DRBC Commissioners
Executive Director Steven Tambini
Delaware River Basin Commission
25 Cosey Road
P.O. Box 7360
West Trenton, NJ 08628-0360
Also via email to penneastapp@drbc.gov

July 17, 2020

RE: Comments on PennEast's May, 2020 Application to the DRBC

Figure 2 - PennEast FEMA Floodplain map near mile marker 26

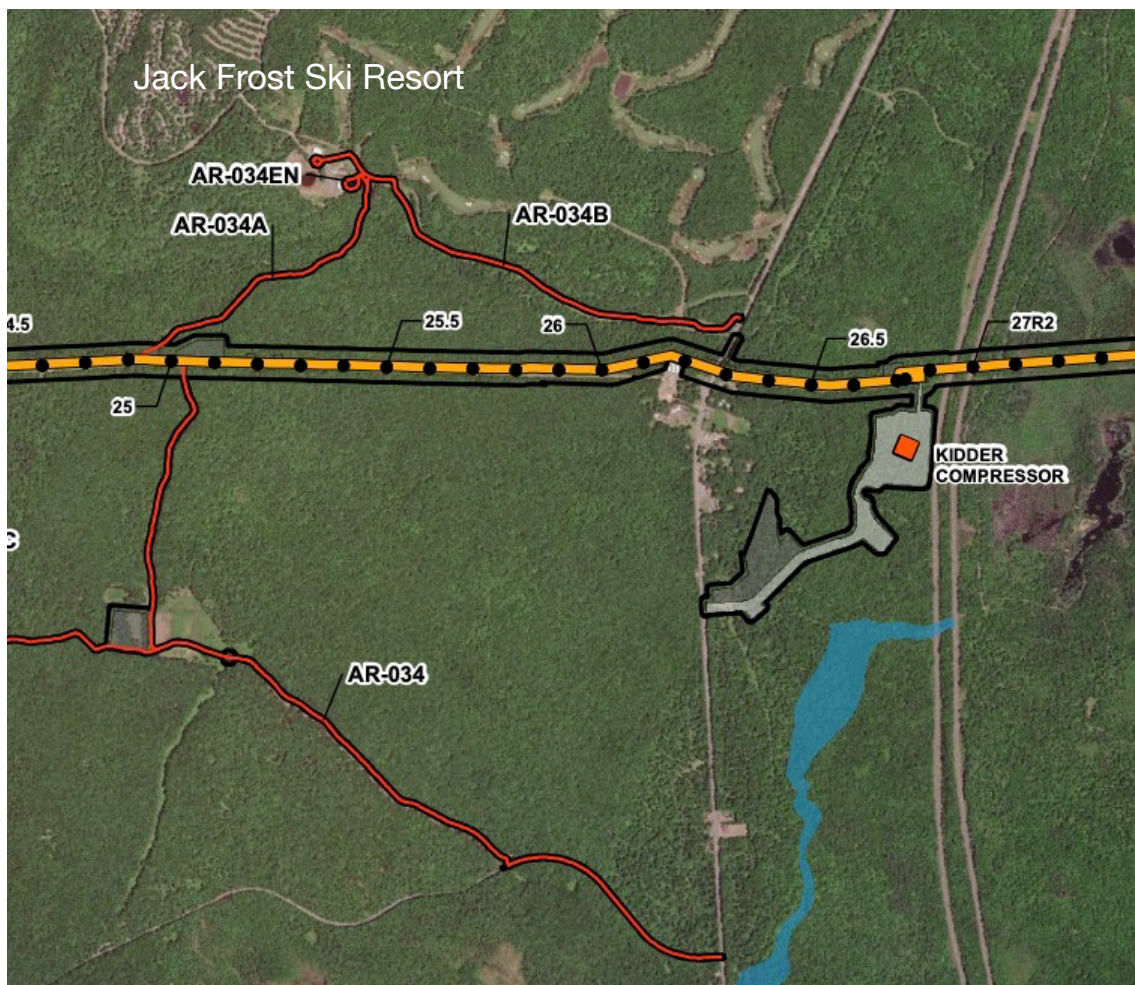
The AR-034B, AR-034EN, and AR034A access roads marked there seem to be going to a specific facility, specifically part of the Jack Frost Ski Resort, which we have labelled on the map.

As it turns out, these two access roads are indeed specifically designated as roads for water trucks, and PennEast intends to use these roads to draw water out of Big Boulder Lake and Tobyhanna Creek at Jack Frost.

Figure 6 - Length of pipeline traversal within Beltzville Reservoir & State Park

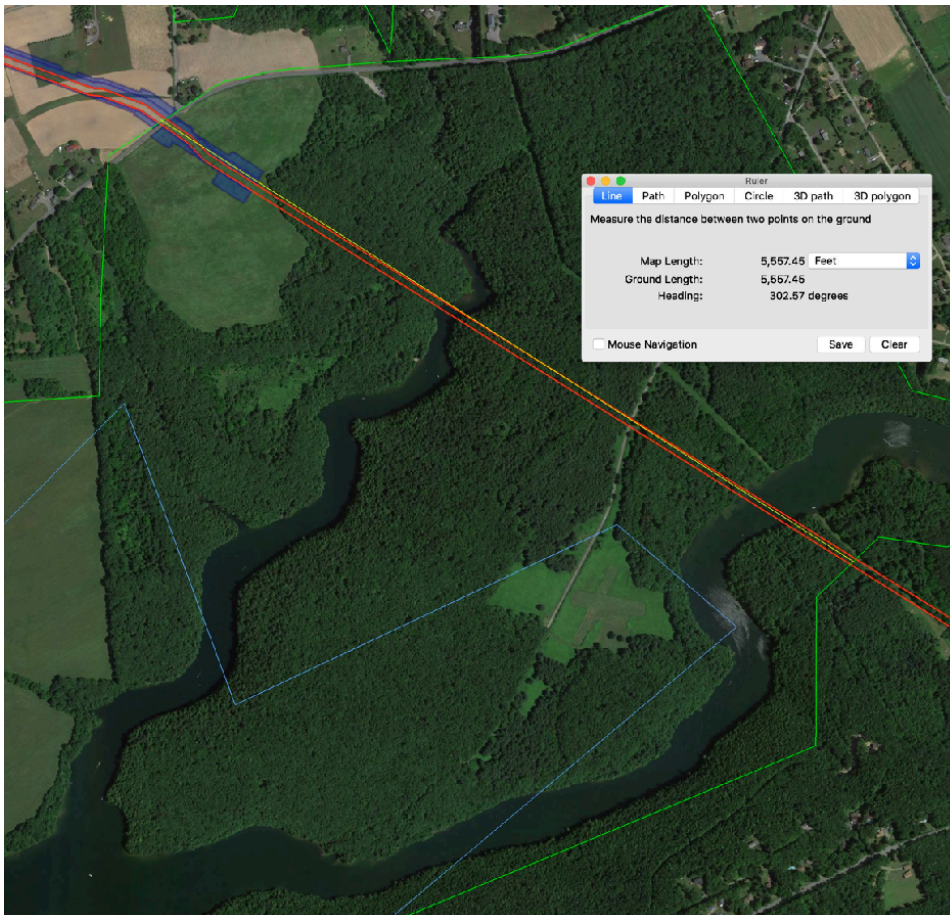
The Beltzville State Park numbers look correct, and helped serve as a benchmark for our findings. Figure 6 shows our rough Google Earth measurement of the pipeline traversing the park boundaries.

The yellow line measurement along the ROW shows roughly 5,550 feet. To get acreage we use the formula:

This matches PennEast's 6.4 acre number with rounding. Using the same formula with a 30' ROW gets us 3.82 acres, which also matches nicely with PennEast's rounded down 3.8 acres.

Figure 8 - Erosion and Sediment Control Plan Alignment Index

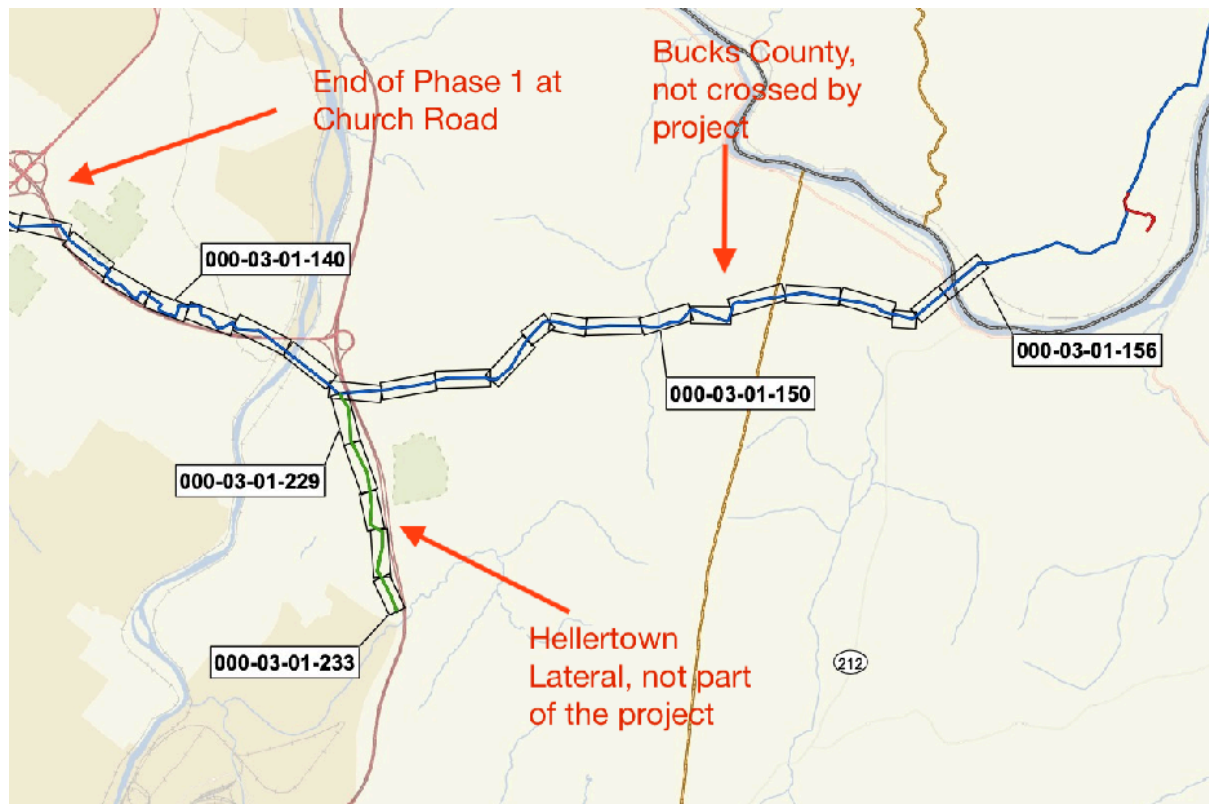
As the annotations show, PennEast is portraying areas in Northampton County and Bucks County, PA that are not part of this project. We show the End of Phase 1 at Church Road on the left of the drawing. The remaining portions, including the Hellertown Lateral, are not in PennEast's Phase 1 project at all.

This error may be due to PennEast arbitrarily reusing various parts of applications it has made to PADEP and FERC in the past. In this case, it appears it submitted some portions of an outdated PADEP application. This is part of a larger pattern of sloppiness by PennEast in its application to the Commission.

Figure 12 - Lehigh River FEMA flood plain crossing

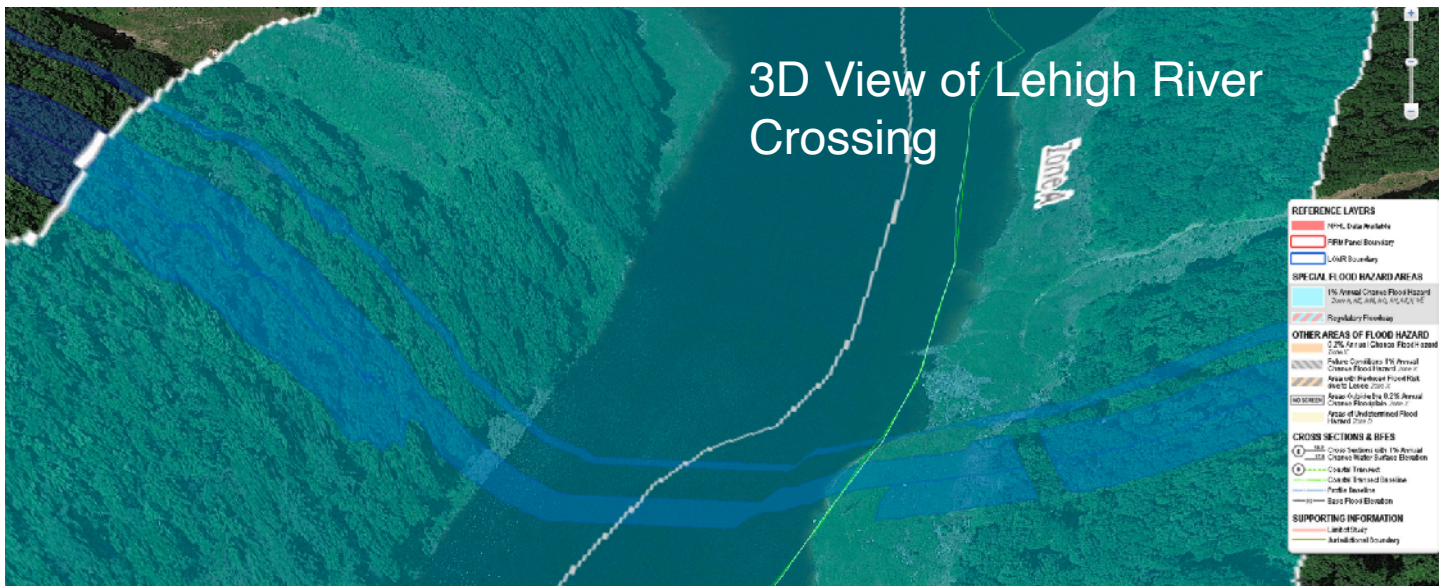
As the 3D representation makes clear, PennEast will be cutting several acres of trees on either side of the river within the flood zone. To make matters worse, as you can see the blue temporary construction corridor continues through the river. This means PennEast is not boring under the river at this site, but instead is open trenching through it. This will release a massive amount of sedimentation downstream.

Figure 13 - Google Earth View of first 40 miles of PennEast route

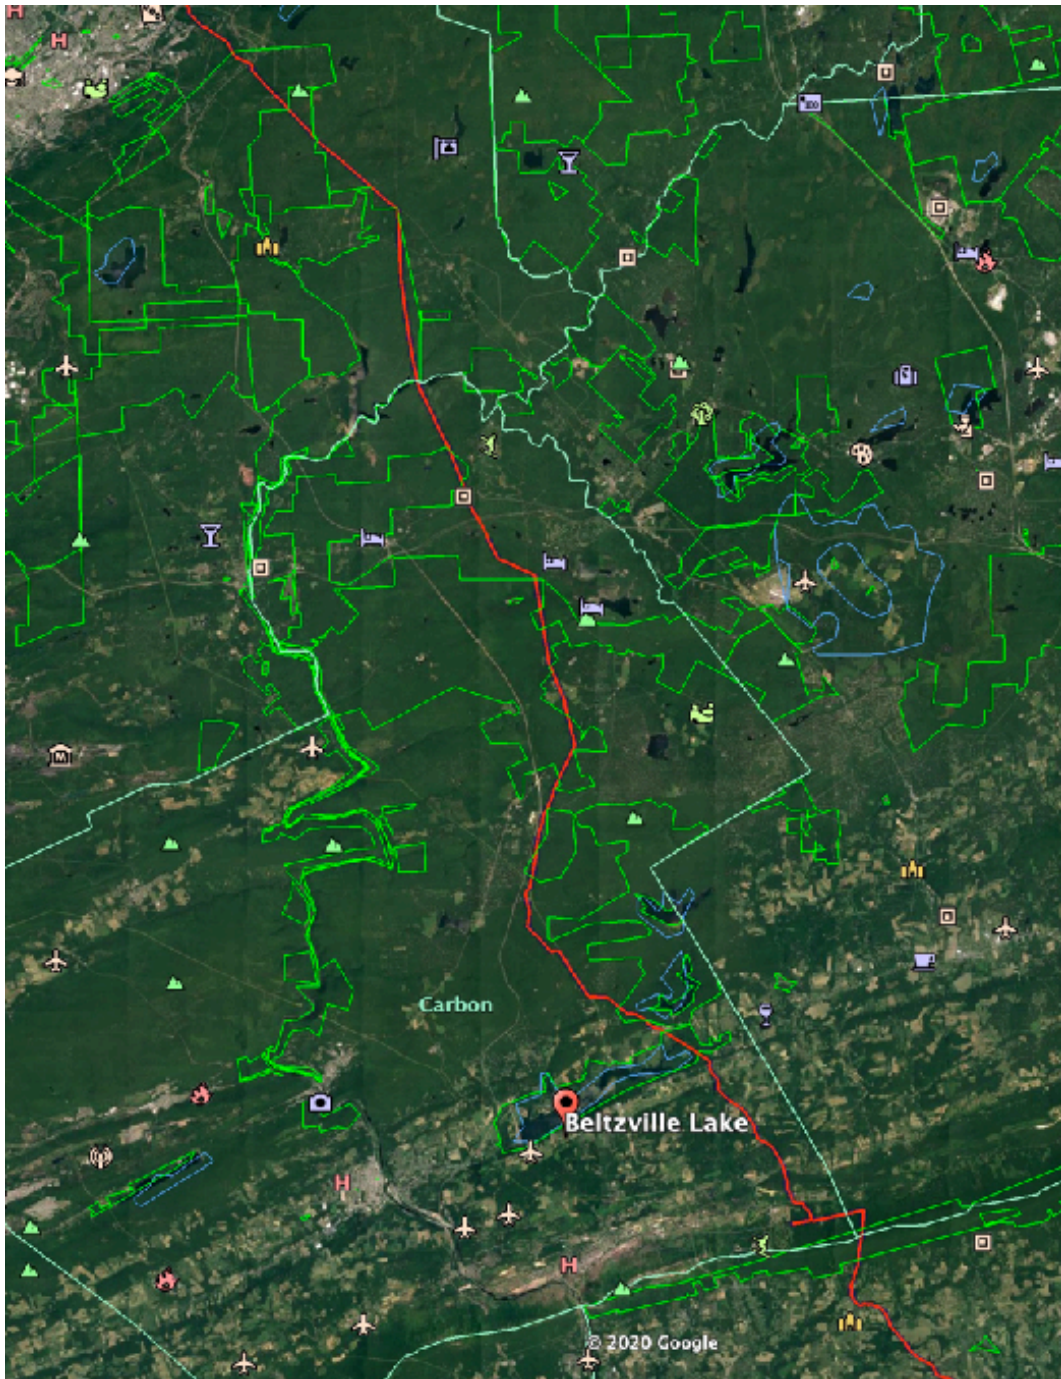
This statement by PennEast is astounding. The map shown in Figure 13 shows the first 40 miles of the project within the Delaware River Basin in Google Earth. The red line is the PennEast pipeline center line.

This entire 40-mile portion of the pipeline route predominantly targets state parks, state game lands, reservoirs and surrounding conserved lands, and national historic and scenic areas such as the Appalachian Trail.
